Pacer Downs HVAC Replacement Phase I

Project No.: FP00000216

Addendum No. 1

Re: Pacer Downs HVAC Replacement Phase I
Subject: Pre-Bid Meeting Minutes

1 NEGATIVE PRESSURE CONDENSATE DRAIN TRAP

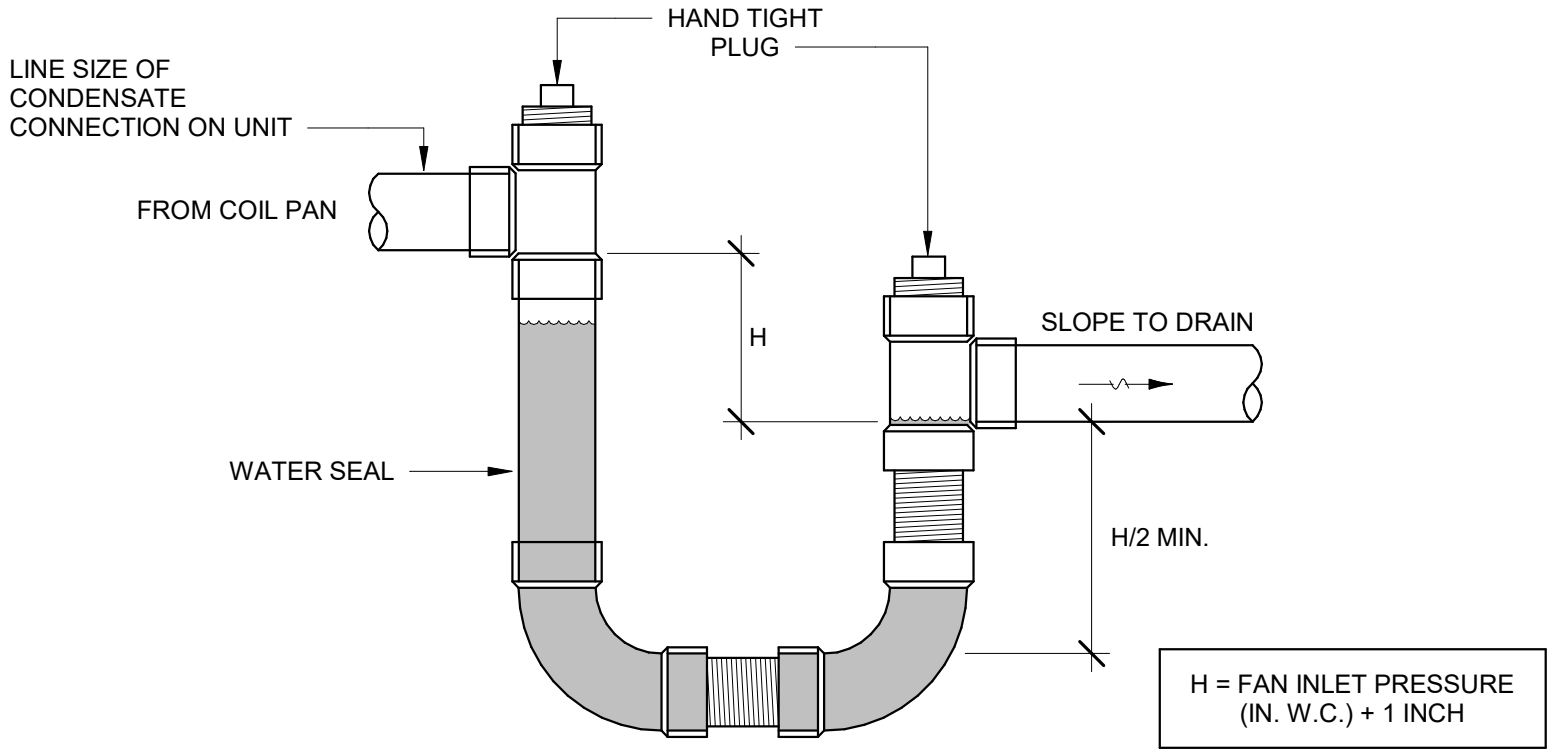
6. Q: Is there a need for a P-trap on the condensate piping?
A: Yes a P-Trap is required for the primary condensate drain line per the manufacturer's recommendations. See attached detail for Condensate Trap required.
